UNITED STATES  
NUCLEAR REGULATORY COMMISSION  
WASHINGTON, D. C. 20555

SAFETY EVALUATION BY THE OFFICE OF NUCLEAR REACTOR REGULATION  
RELATING TO ELECTRICAL SYSTEM CHANGES FOR FIRE PROTECTION  
CONNECTICUT YANKEE ATOMIC POWER COMPANY  
HADDAM NECK PLANT  
DOCKET NO. 50-213

AC SYSTEM NEW CONFIGURATION

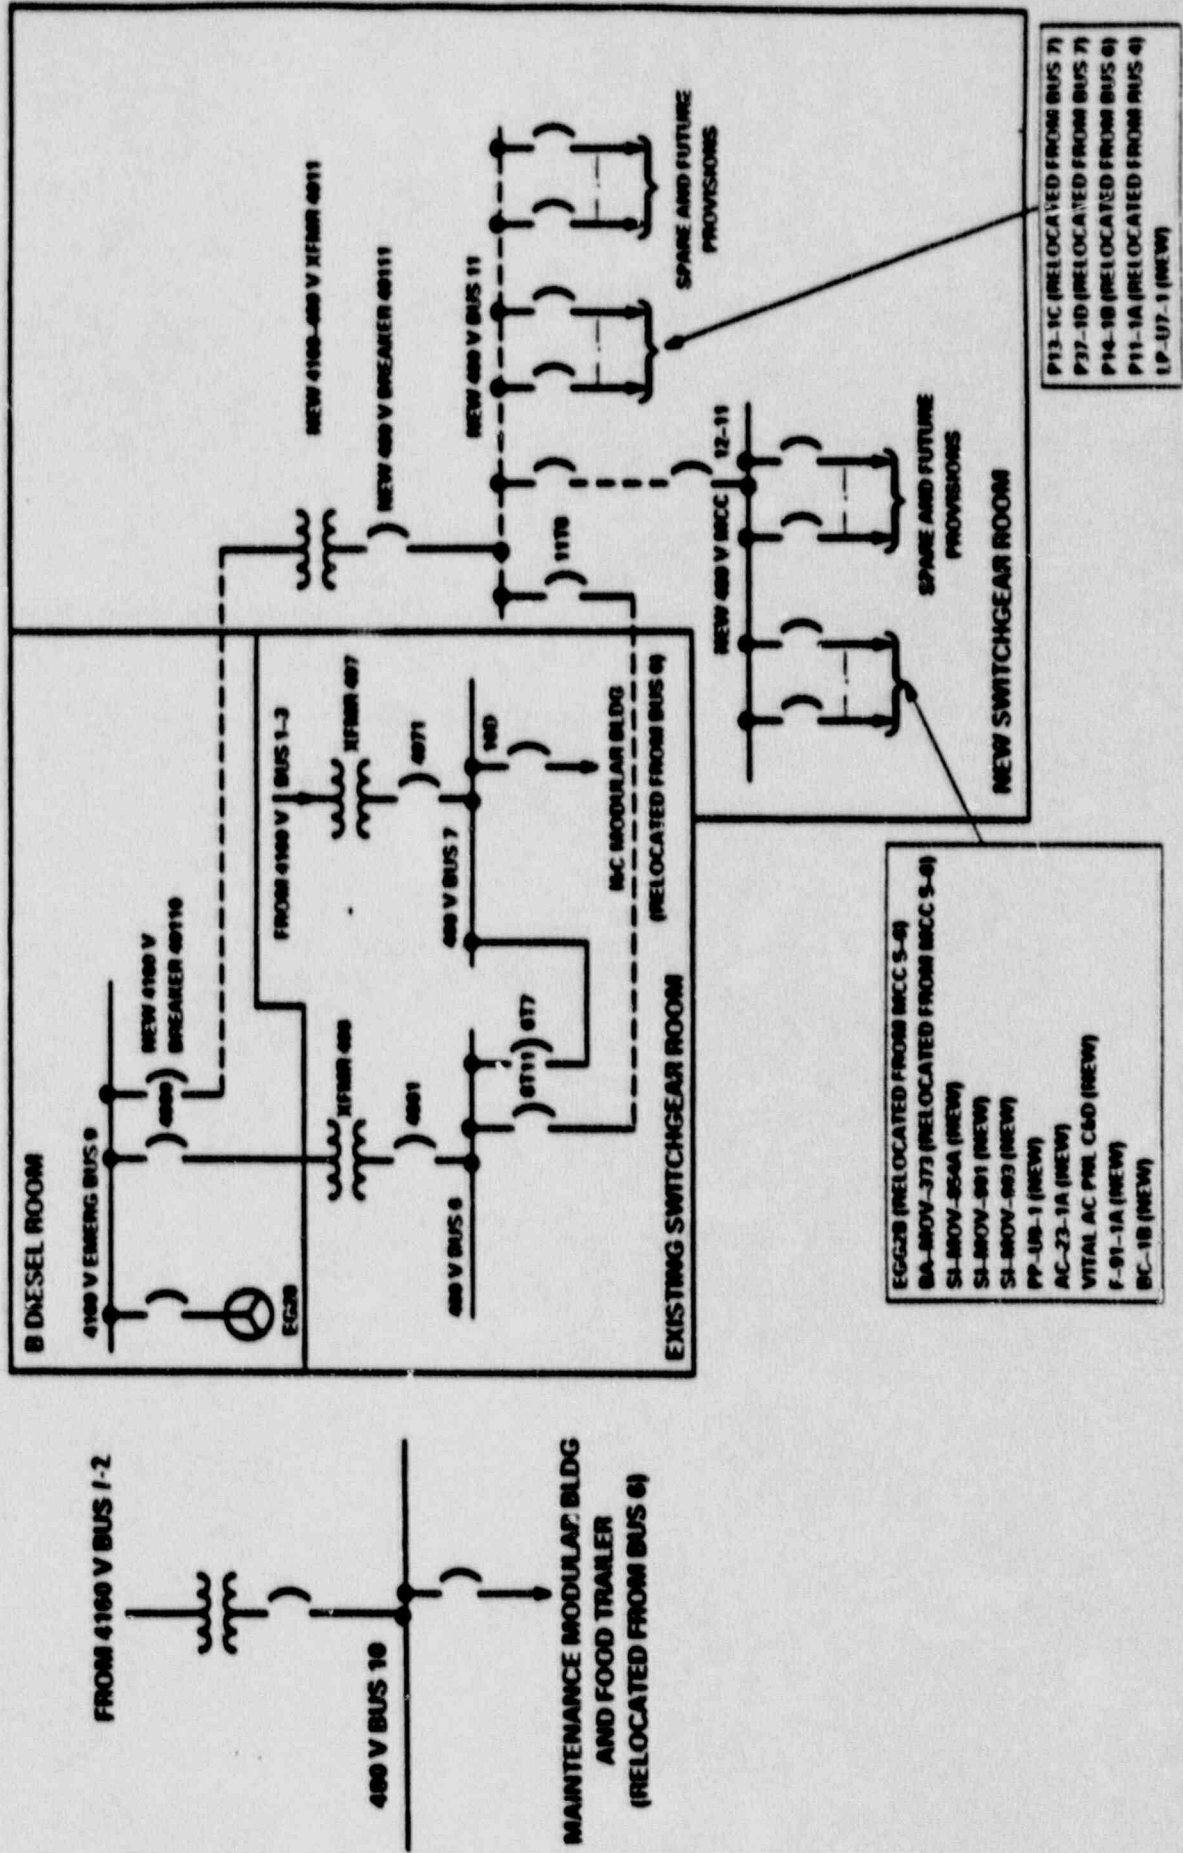
Figure 1 shows the system changes to the 4160V and 480V ac emergency systems. The new 480V buses in the new switchgear room will be powered through a new 4160V/480V transformer powered from the existing Division B emergency bus. An alternate, normally open supply tie is provided from a 480V bus in the existing switchgear room. Division B equipment, such as the diesel generator auxiliaries, battery chargers, and the constant voltage transformers (CVTs) to the vital ac panel will be powered from the new 480V Division B buses. Other electrical equipment, redundant to that powered by Division A and necessary for shutdown in the event of fires in other areas, will also be powered from these new 480V Division B buses.

FIGURE 2

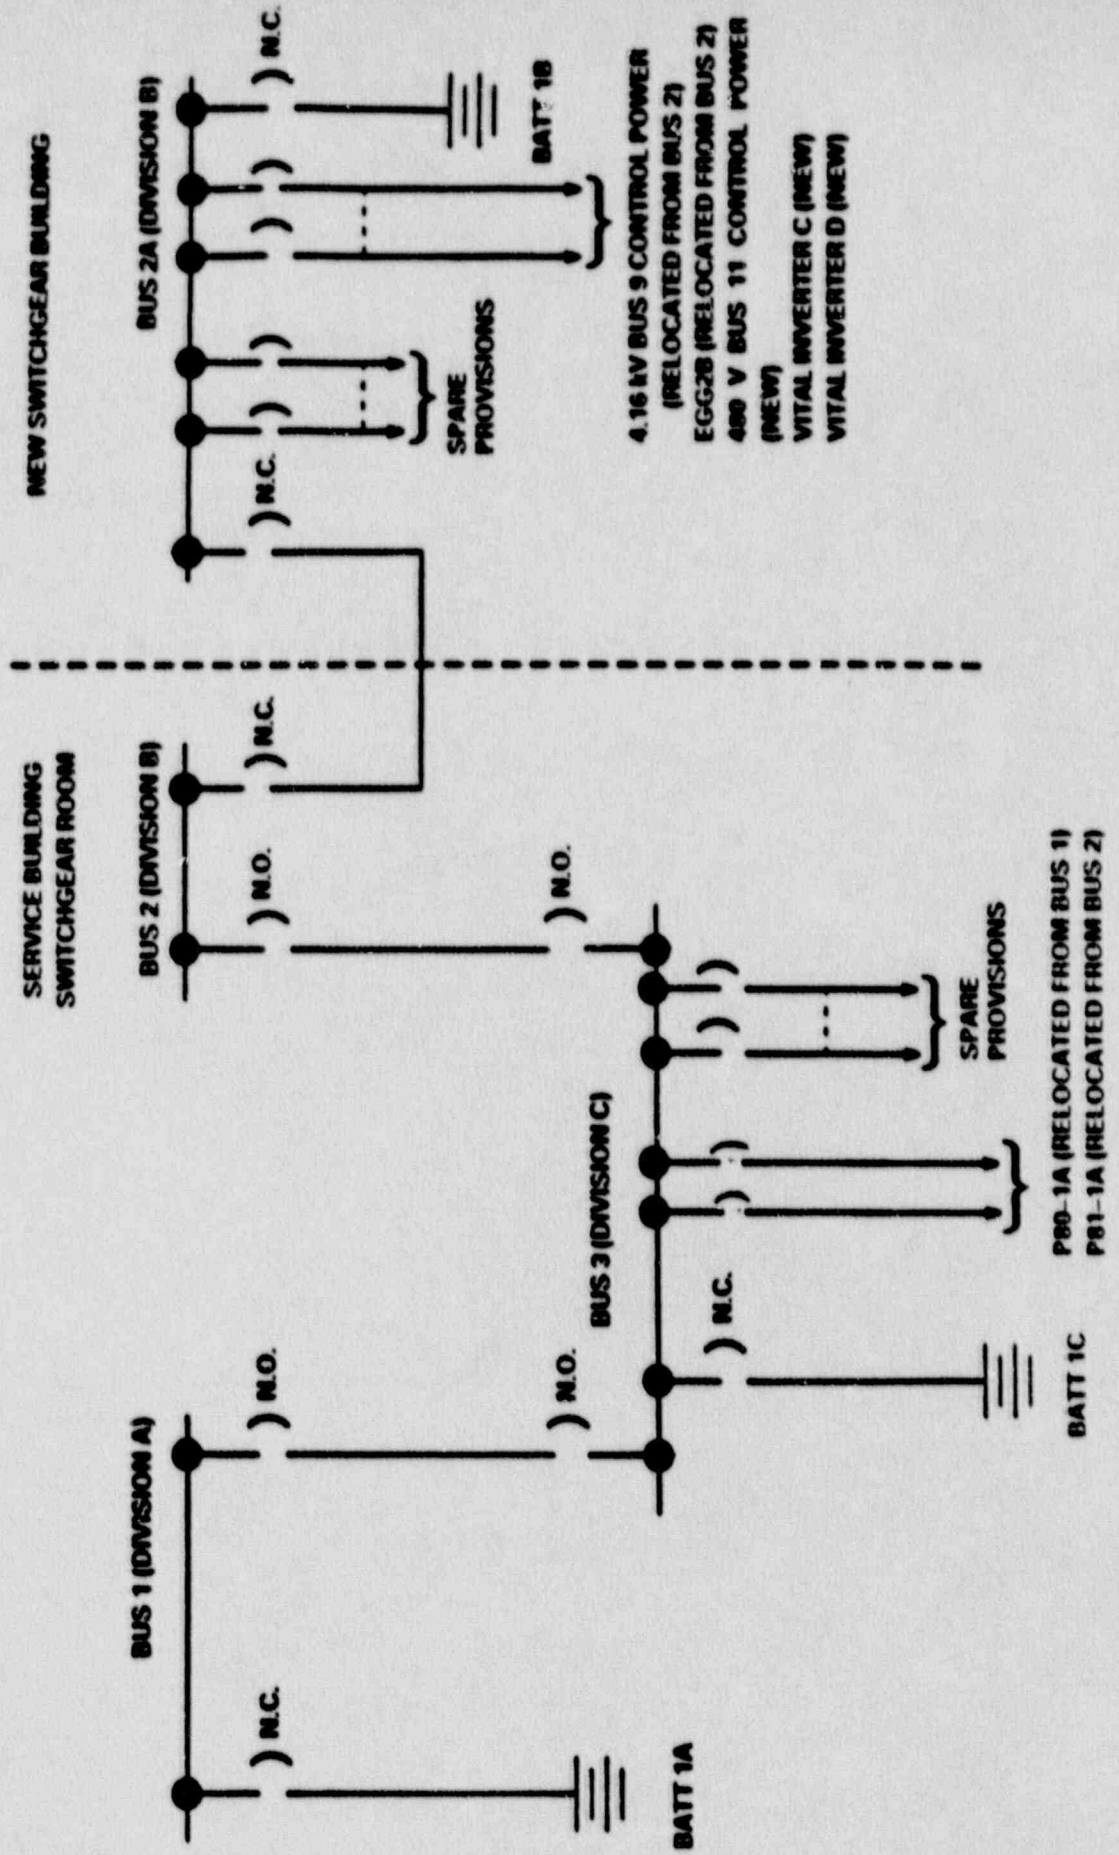
Figure 2 shows the system changes to the 125V dc emergency buses. The Division B 125V dc bus will essentially be extended into the new switchgear room by a tie from the existing Division B 125V dc bus. The Division B 125V dc bus extension will supply power to the Division B inverters for the 120V ac vital panels, to the Division B emergency diesel generator (EDG) and its associated 4160V bus, and to selected loads required for safe shutdown in event of fires in other areas. Battery 1B is an existing battery which will be relocated from the existing switchgear room to the new switchgear room.

FIGURE 3

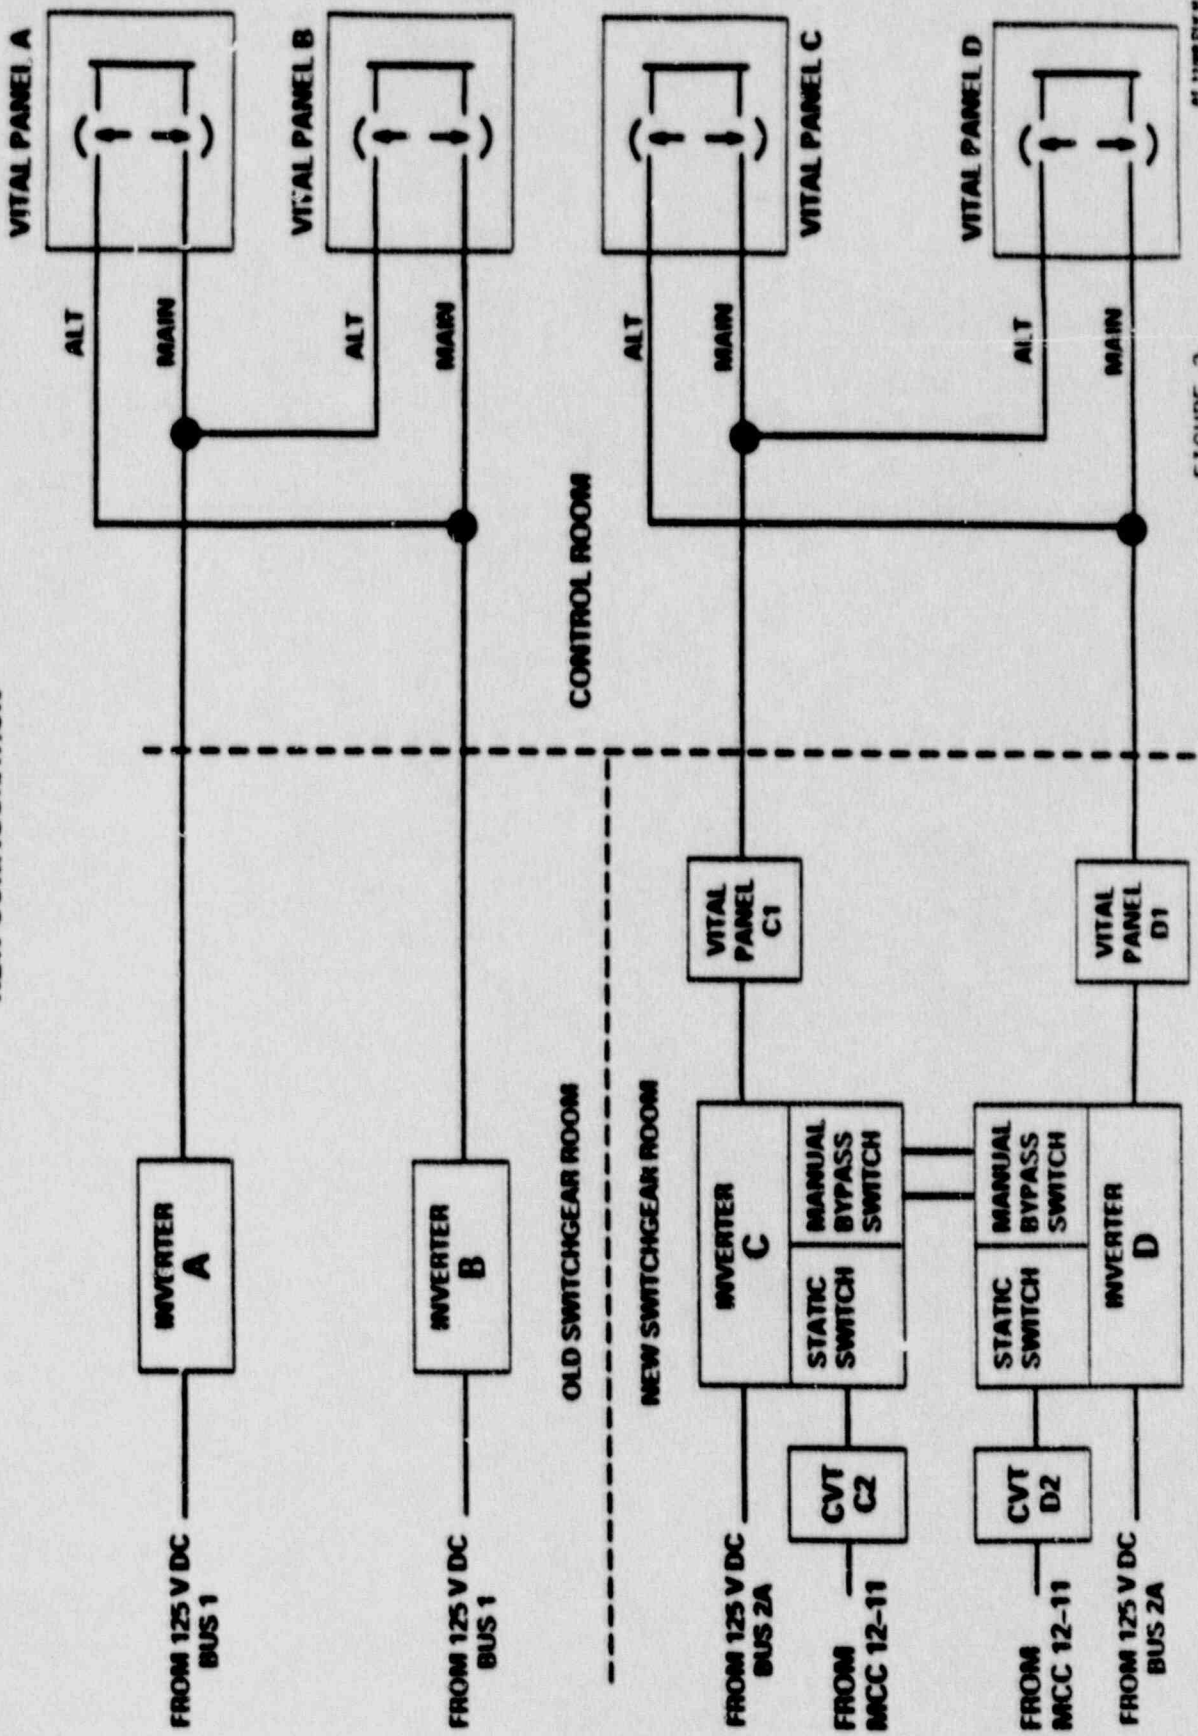
Figure 3 shows the system additions for the new switchgear room for power supply to the Division B vital panels. These vital panels will serve as the power source for a new remote instrument panel to be located in the new switchgear room. In addition to the instrumentation required for the new switchgear room, the instrument panel will include transfer provisions and control circuitry for remote speed control of the metering charging pump and control of the suction
